**COMMISSION OF ARCHITECTURAL REVIEW
STAFF REPORT
July 24, 2018 Meeting**

14. **COA-037950-2018** (M. McGinnis) **514 North 26th Street
Church Hill North Old and Historic District**

Project Description: **Construct a new single family dwelling.**

1905 Sanborn Map of the 500 block of North 26th Street

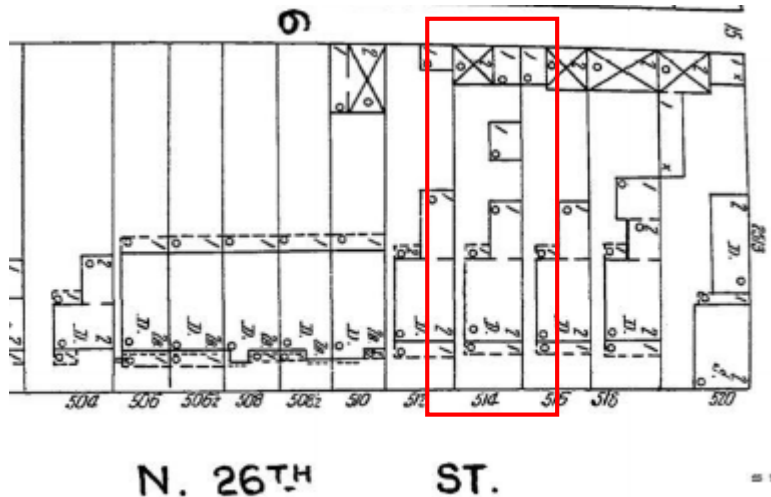
The historic pattern for the block is shown below.
